Public 2021 DSPM Draft Update Review Comments						Comment Related DSPM Language	STAFF Response	
Comment #	Page #	Section #	Sub Section	DS&PM Statement	Comment	REFERENCED VERBIAGE	DEPARTMENT	STATUS
1	43	1-2.700		Inspection approval is not construed as approval if case is deemed to be in violation of City code.	Why would inspector approve a case if case is in violation? If a case is in violation & violation item is not resolved, inspection should not approve it.	Construction or work for which a permit is required shall be subject to inspection and such construction or work shall remain accessible and exposed for inspection purposes until approved. Approval as a result of an inspection shall not be construed to be an approval of a violation of the provisions of any codes or ordinances of the City of Scottsdale. Inspections are made for building, electrical, mechanical, plumbing, and zoning compliance for residential, commercial and industrial development, and for the remodeling of existing buildings. Water, sewer, paving, concrete and grading activities also require city inspection. As part of the development process all permitted construction activities must be inspected by the city

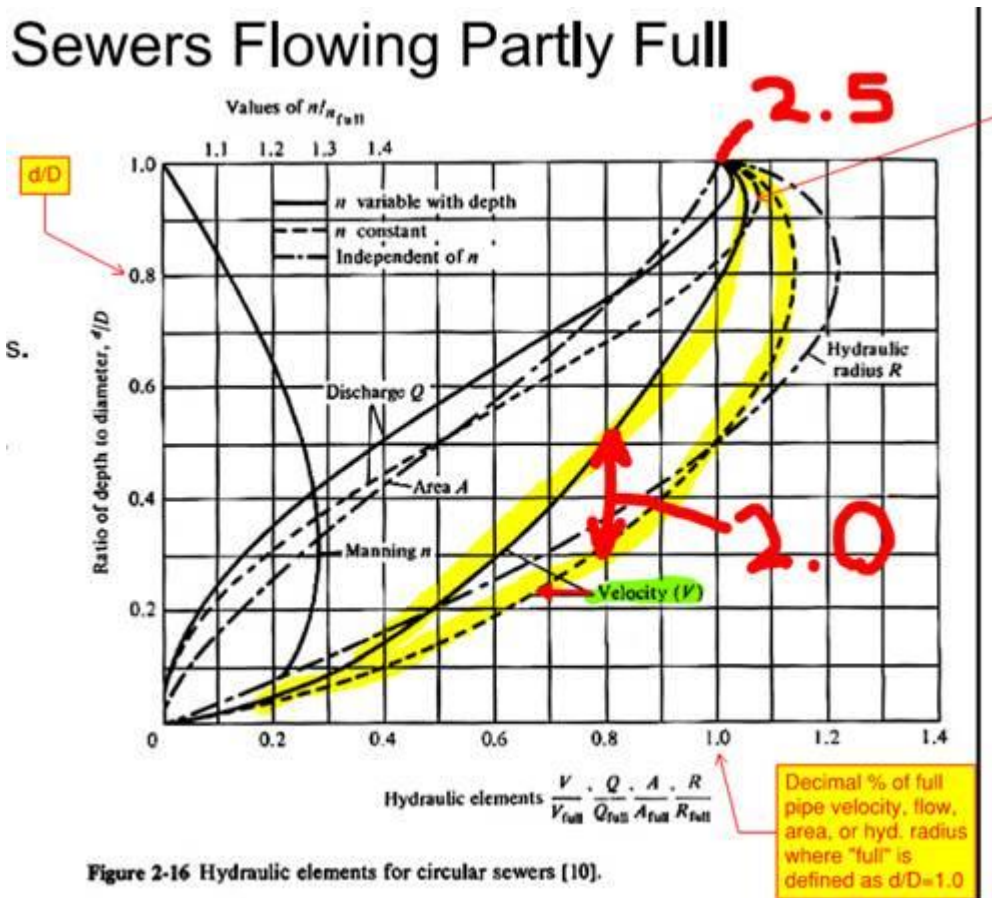
DRB Comment: 2.0-fps should be allowed if 2.5 is not physically achievable. This restriction happens a lot.

Water Resources Engineering Response: 2.5fps is targeted so that greater than 2.0 is achieved for a larger range of the d/D (pipe fullness). See below. Per current requirement, 2 fps or greater will be achieved from d/D of 0.3-0.5 all the way to 1.0. Below 0.3- 0.5 the velocity will be less than 2fps. The variability occurs depending on using a constant versus depth-dependent Manning's "n" value. Generally, we are using constant n thus velocities will be greater than 2fps for a larger range of d/D i.e. 0.3 to 1.0, which is what we want. If we made required velocity 2fps at d/D equals 1.0 the range would be a narrower 0.5 to 1.0. That being said, where no other feasible and reasonable alternative exists, we sometimes, on a case by case basis and weighing all of the information, will allow 2fps at d/D=1.0. Higher slopes/velocities will ensure solids do not settle out of the flow causing maintenance and odor issues. Higher slopes also convey appreciably more flow, thus a longer effective useful life of the sewer before needing to be potentially upsized. See below for graphical description of description above.

MAG detail below

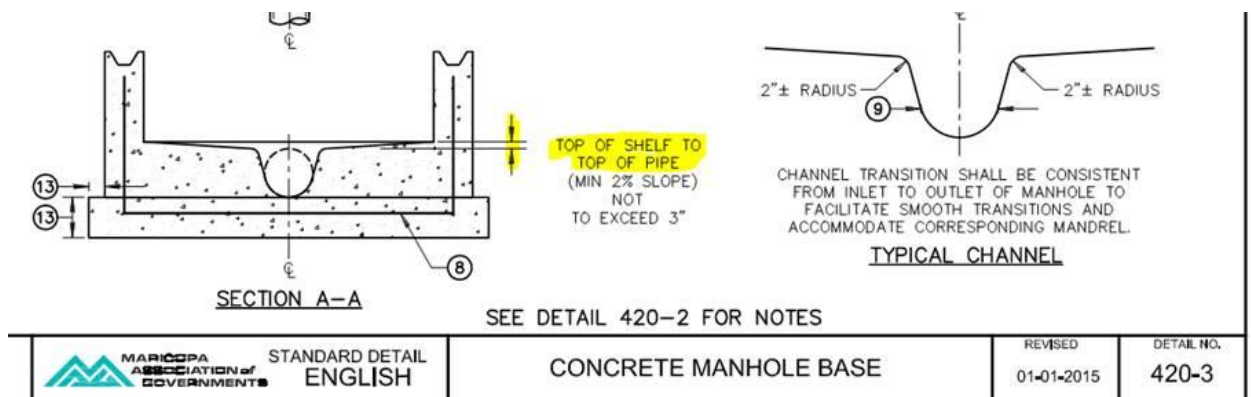
DRB Comment: *What's the difference between 1"/foot minimum slope & 0.10' minimum drop? Which one controls?*

Water Resources Engineering response: The difference between the two is slope for manhole "shelf" or bench perpendicular to the flow/trough/channel versus drop across the manhole in the direction of flow. Per DS&PM the manhole shelf/bench shall be sloped 1"/12" towards the trough/channel or 8.3%. Contrast this with MAG minimum below that lists 2% or 0.24"/12". The COS requirement thus tends toward the upper MAG range of 3" shown below with shelf drop values of 2" to 2.5" on a 4-5ft diameter manhole, exact value depending on diameter of pipe.
